DEVELOPMENT REVIEW COORDINATOR
POST APPROVAL PROJECT CHECKLIST

Project Name: One Joy Place - 12 condos new build

Project Name: Onejoy Place Condominium - Twelve Unit Residential Building
Project ID: 2017-103 (Subdivision and Site Plan)
2017-128 (Conditional Use Inclusionary Zoning)
Address: 1 Joy Place CBL: 045 E049001
Applicant: Onejoy Place LLC
Planner: Jean Fraser

This is print-out of approved plan set, annotated re recent tree amendment confirmed by Tuck stamped, paper, at scale set given to Phil in late March 2018 - not sure if Tuck may have them from the pre con (or Barbara) also pdfs w/ stamp are in e-plan

DATE: 3/7/2017
SCALE: 1"=10'
DESIGNED: MTW
JOB NO: 1704
FILE: 1704-EC.DWG
SHEET **C-2.2**

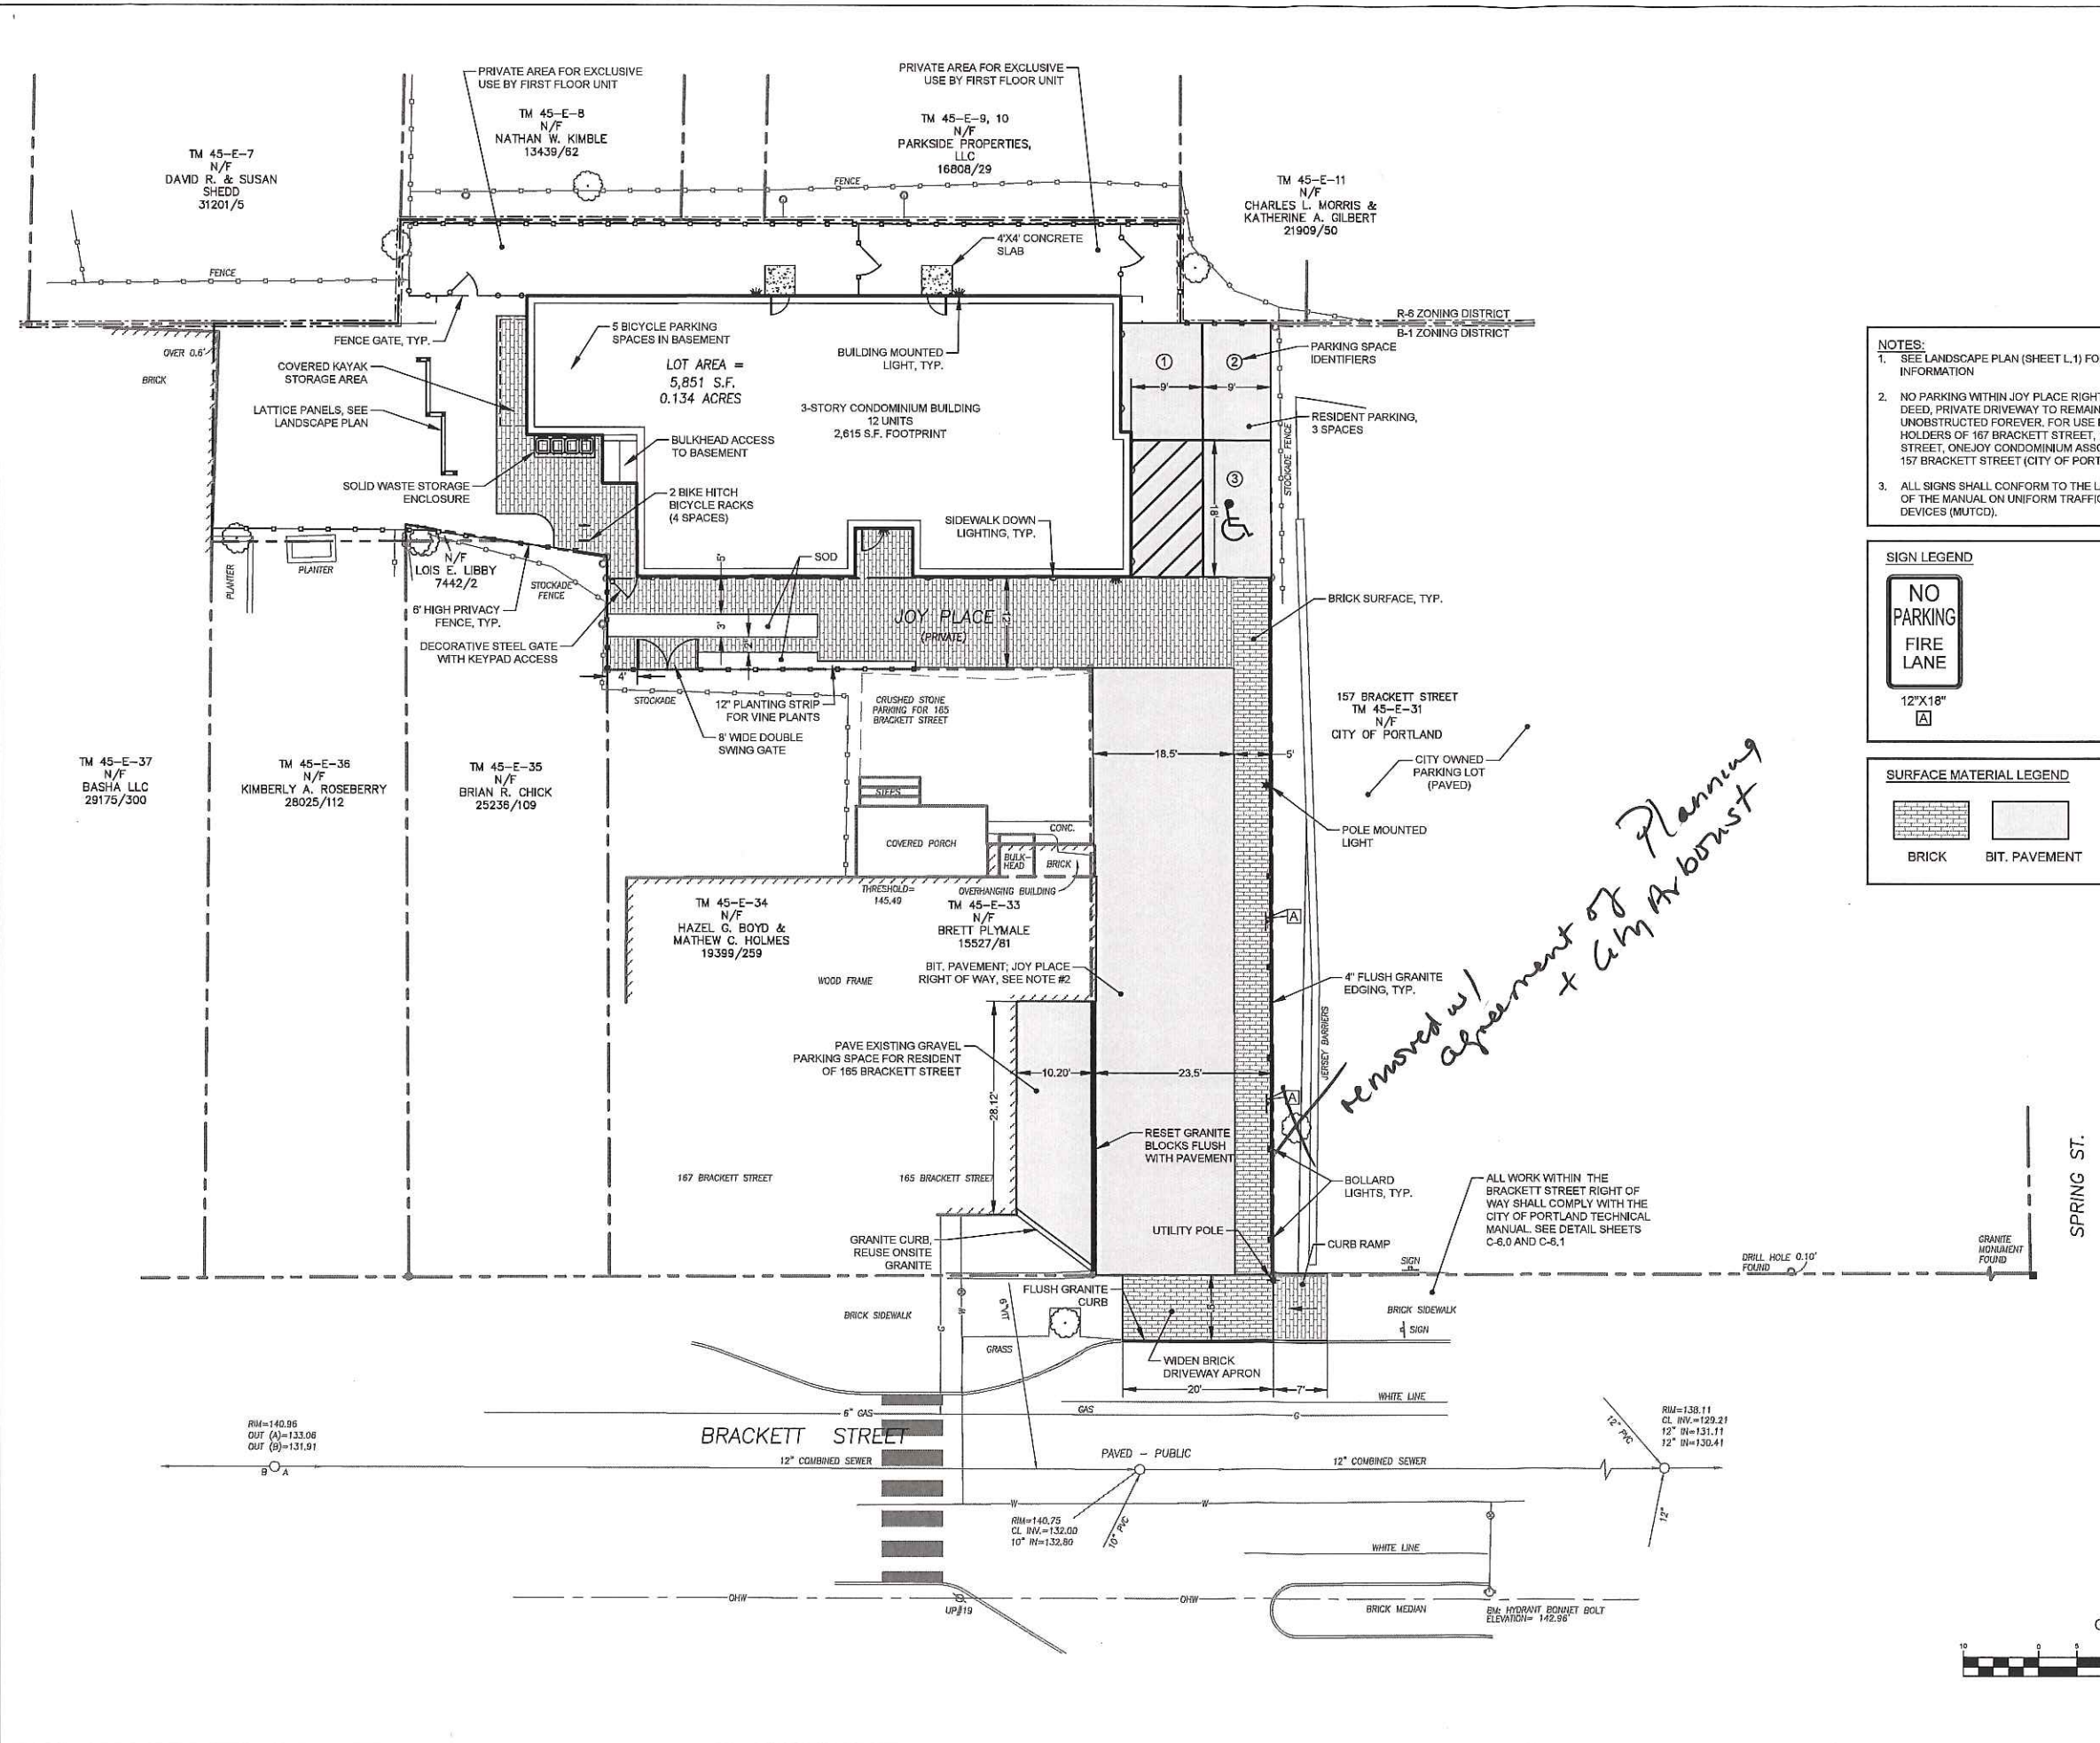
removed w/ agreement of Planning + City Arbust

LANDSCAPE PLAN
L.1
 REV. 7.13.17
 REV. 8.7.17
 REV. 5.28.17

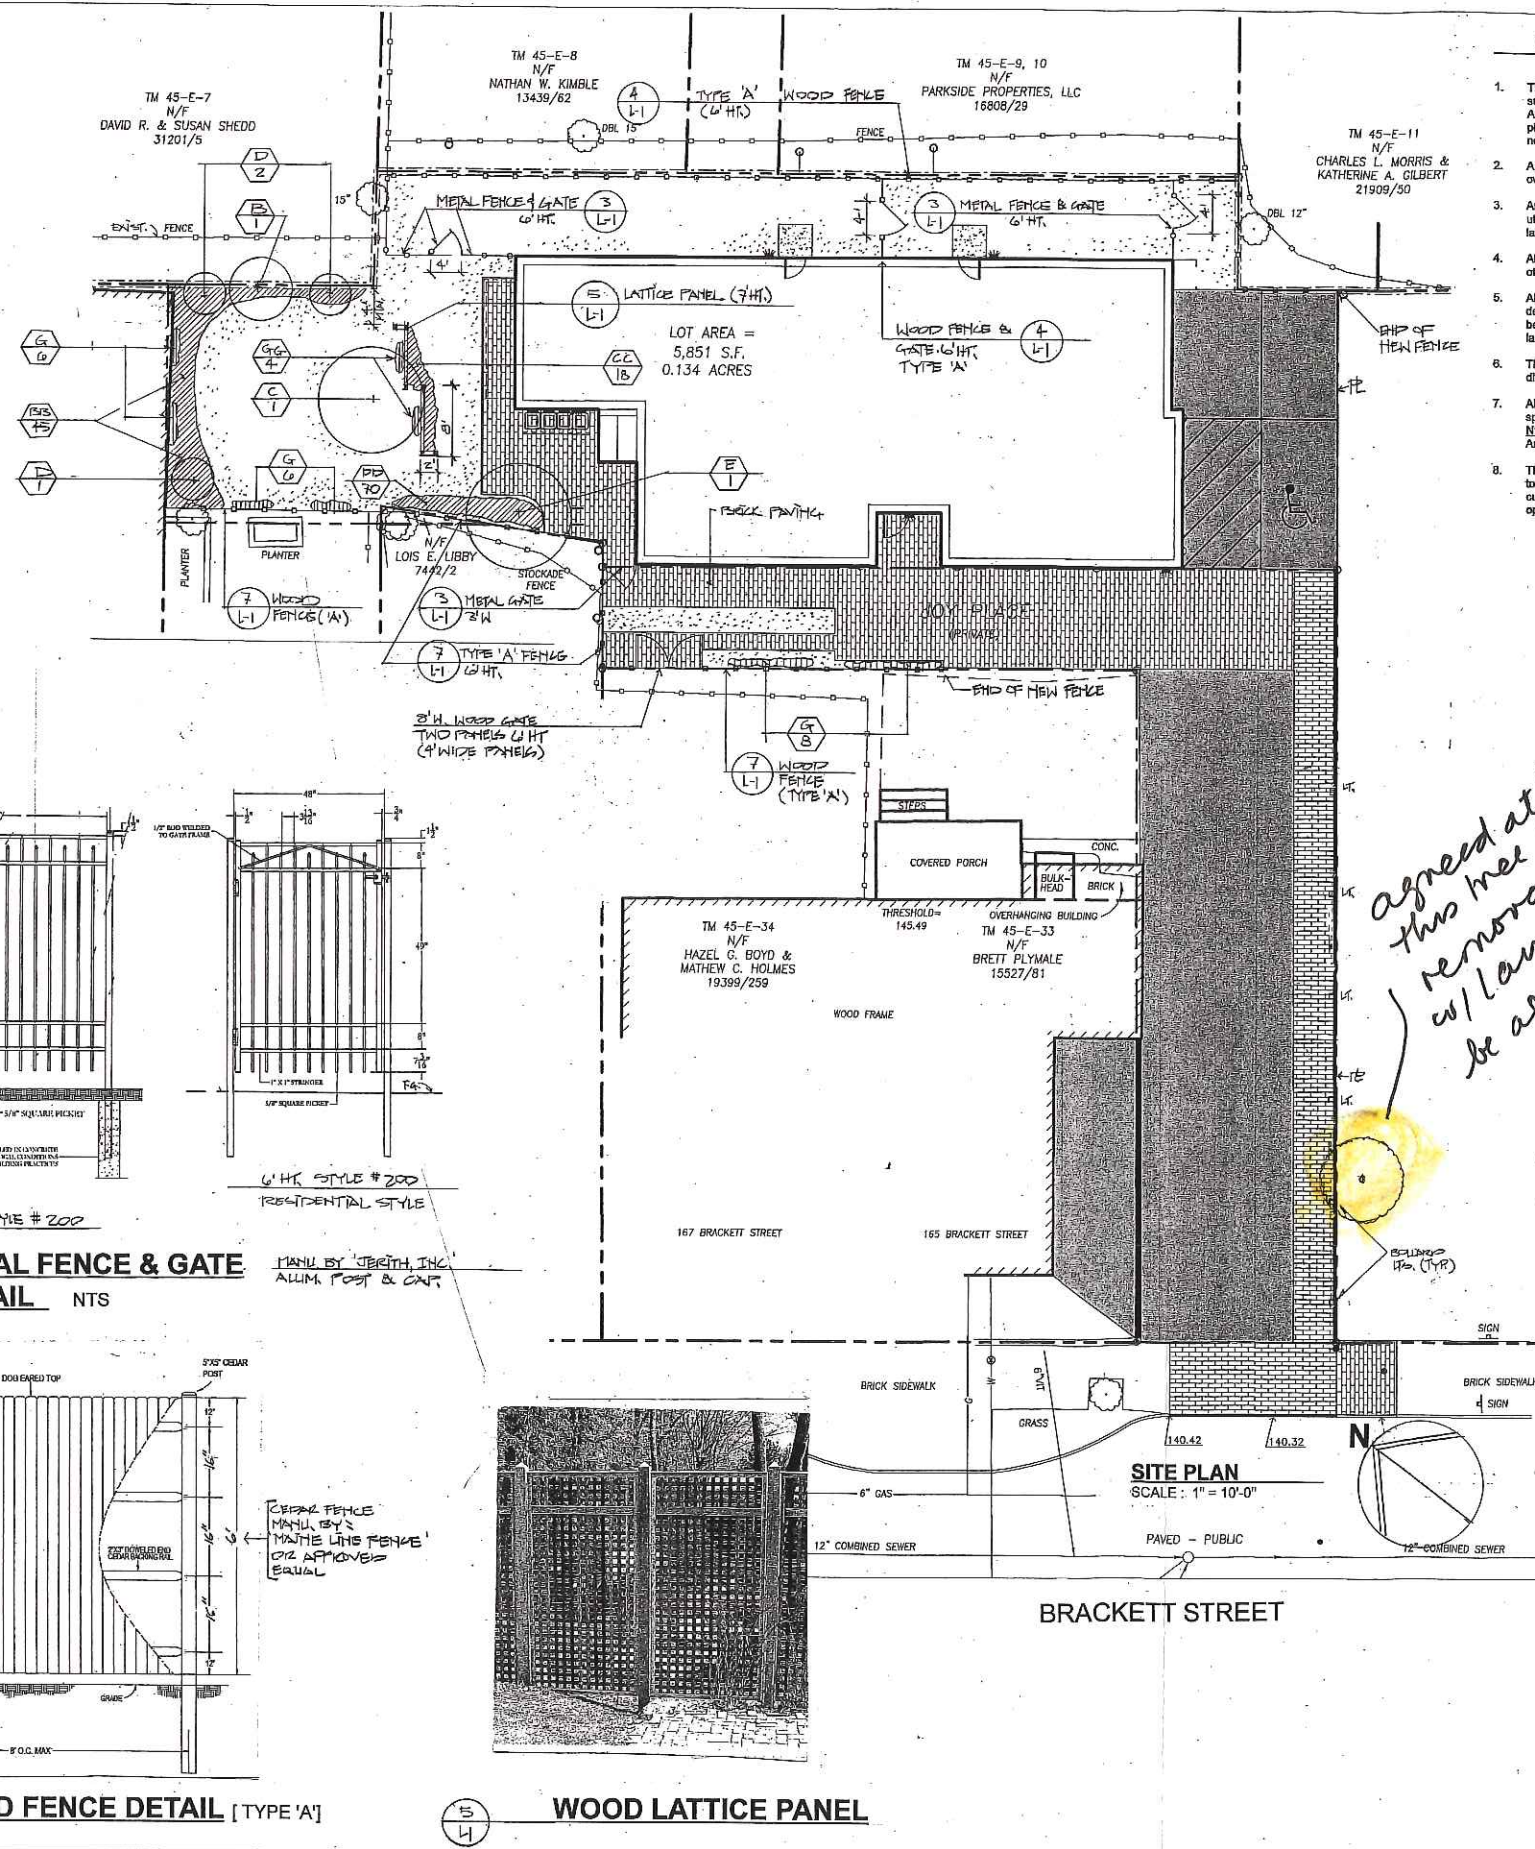
Handwritten notes:
 Agreed at Pro Con
 this tree to be removed - replace with
 w/ land's capping to be agreed Todd/Neil + Jeff Farling (aka Arbaust)

*need Todd, Tuck
+ Jeff T to agree
the replacement
planting ^{incl} on city land
(looks very bare now - July)*
